THE FEASIBILITY STUDY ON PANAMA CITY URBAN TRANSPORTATION LINE-3 PROJECT

Metro Line-3 is planned to cross the Panama Canal by the 4th Panama Canal Bridge, whose study has been implemented in Pre-F/S; therefore, the 4th Panama Canal Bridge was excluded from the scope of works in the Metro Line-3 Study (hereinafter referred to as “the Study”) while the Study targets to review the Pre-F/S.

The objective of the Review is to verify preliminary design of Pre-F/S in order to arrange both studies in same conditions before comparing composite cable-stayed bridge plan in Pre-F/S and arch bridge plan in the Study.

Figure 2.2 General View of Main Bridge

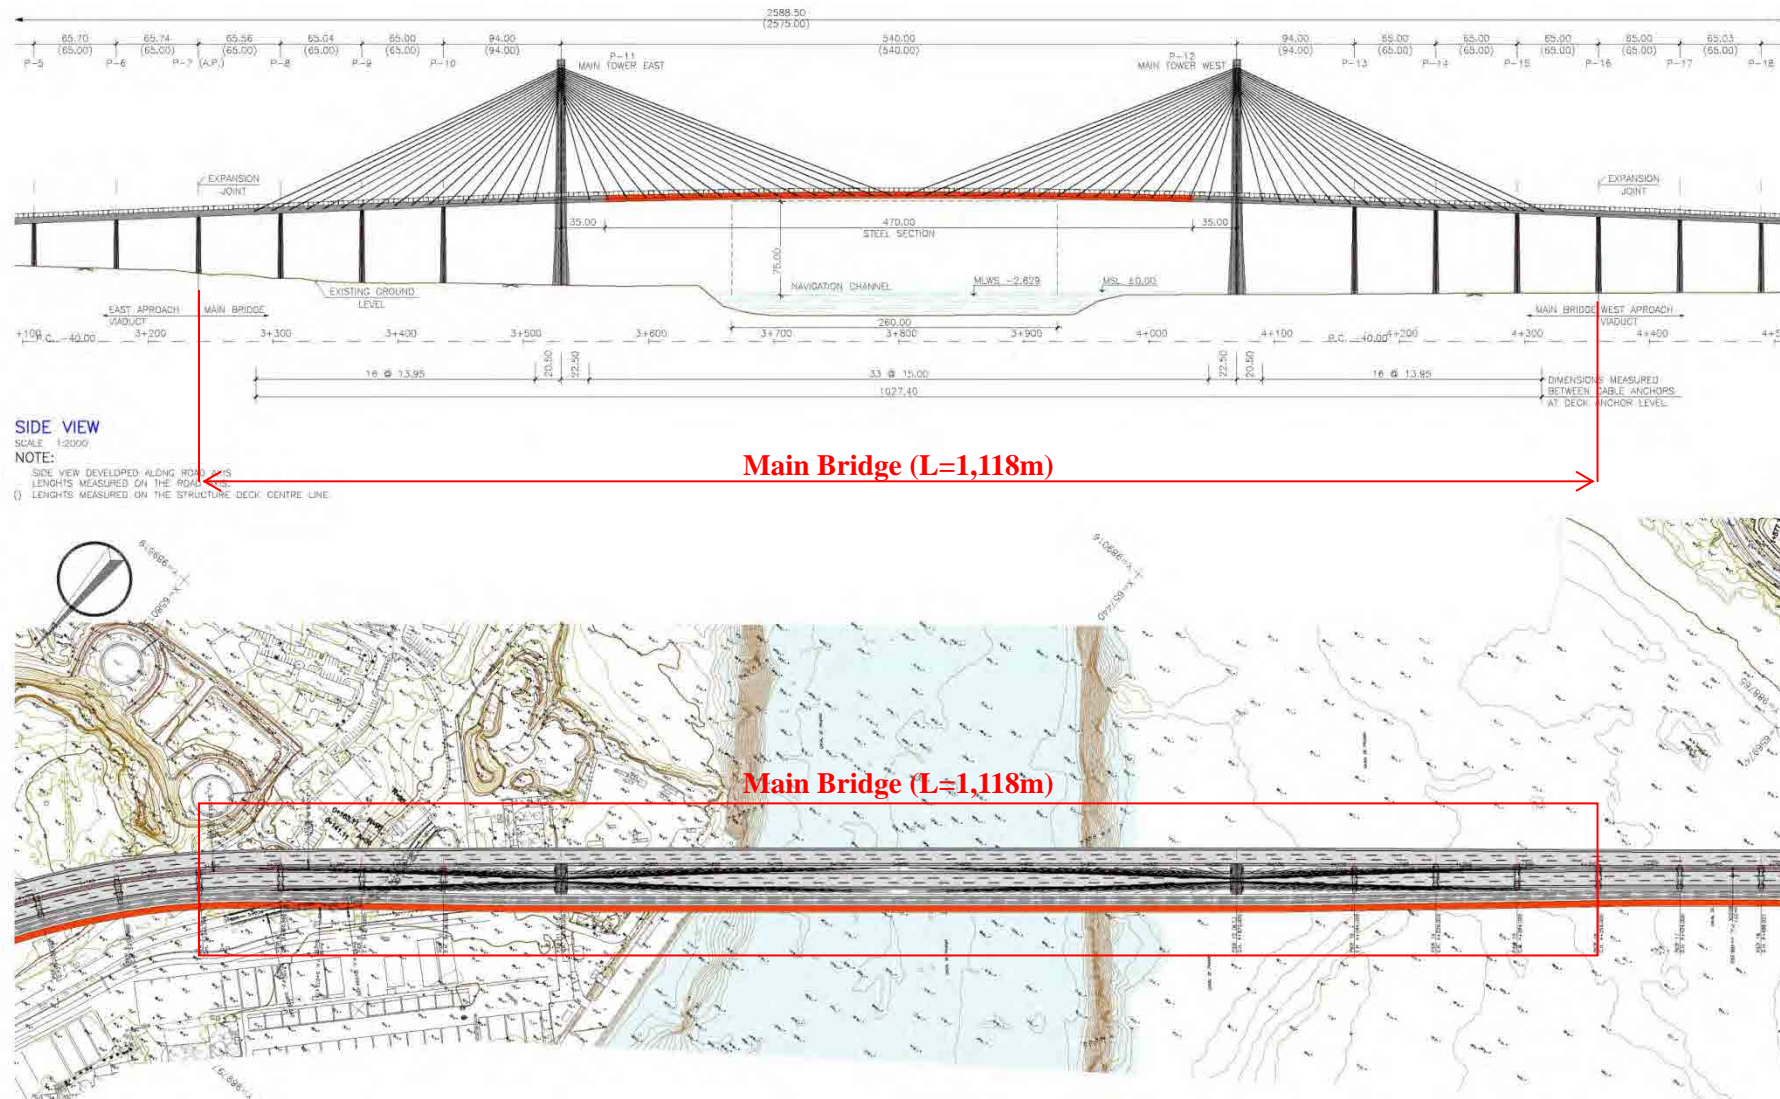
Features in main bridge plan are shown in Table 2.1 and general view of main bridge is shown in Figure 2.2.

Figure 3.3 Navigation Clearance in Pre-F/S

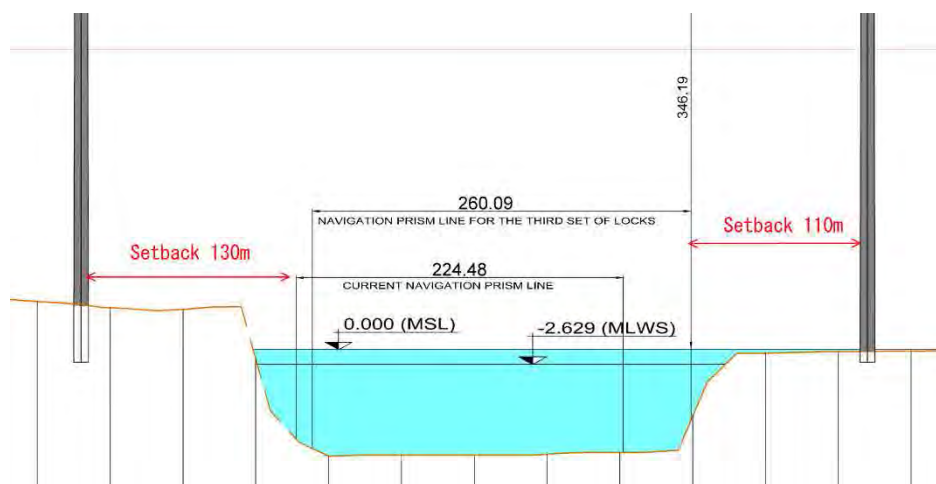
Preconditions for comparison could be regarded as common between the Study and Pre-F/S since length of main span planned in the Study and Pre-F/S is the same, in which setback is more than 100m and enough to reduce the vessel impact force.

Figure 3.5 Cross Section of Main Bridge in Pre-F/S

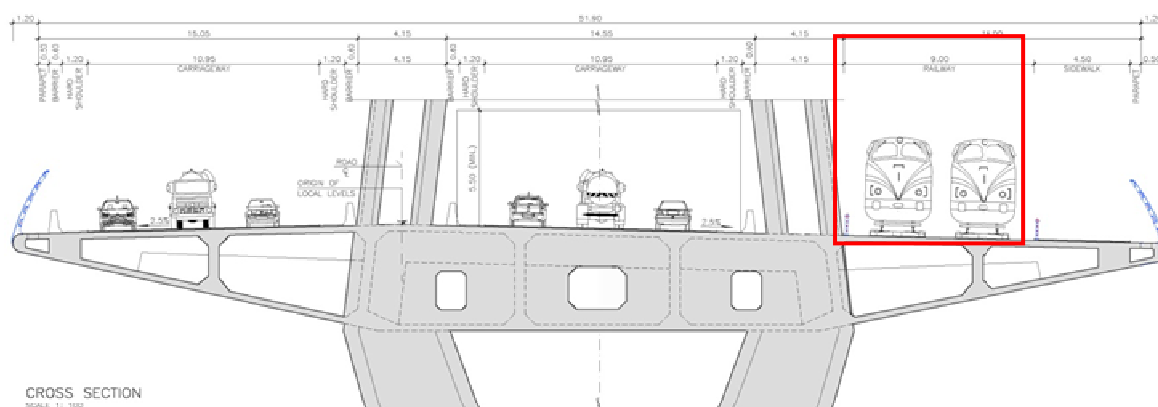
Introduction of concept design report describes advantages of one side arrangement at the approach bridges.

- Any structural measure will not be required on crossing as there is no crossing of metro with a roadway.
- Piers can be reduced from three to two as road section can be supported by one pier.
- More elegance can be assured with more unity in shapes for roadway approaches and the main bridge.

Crossing the metro with a roadway, however, will be required the approach bridge because metro station on both side of the 4th Bridge is planned to place on south side (Balboa, Panama Pacific) while metro is arrange on north side. Therefore, the above structure cannot be found, and superstructure will have to be divided into one and three structures in the approaches. Substructures are divided into 1 to 3 structures.

Figure 5.1 Structural Design Model

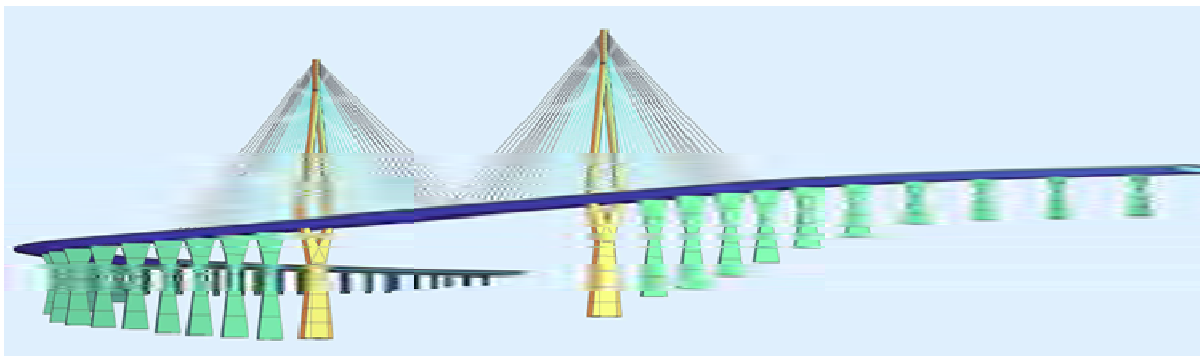
Attached documents of Pre-F/S are only model drawings and input data though analysis has been performed on total model.

Figure 5.2 Structural Design Model

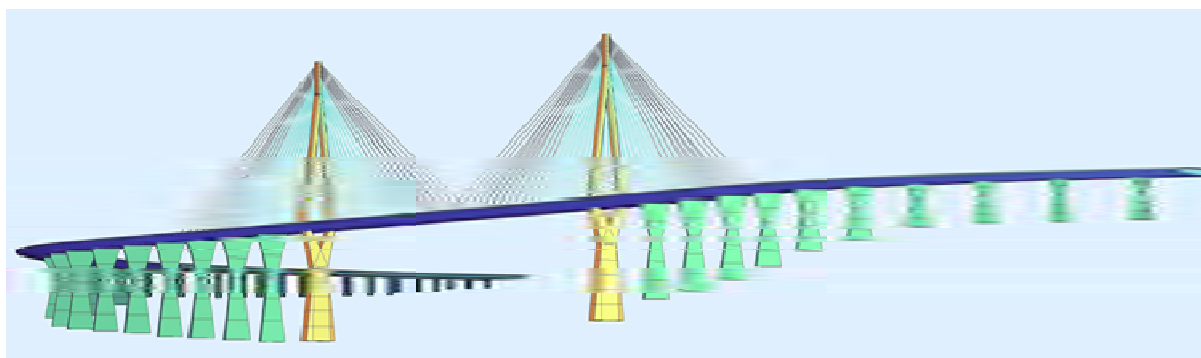
Attached documents of Pre-F/S are only model drawings and input data though analysis is performed on total model.

Validation cannot be performed since the result of analysis and cross section calculation cannot be confirmed, but only model drawings and input data.

Preconditions for comparison could be regarded as common between the Study and Pre-F/S assuming that analysis in Pre-F/S is appropriate based on planning and design condition.
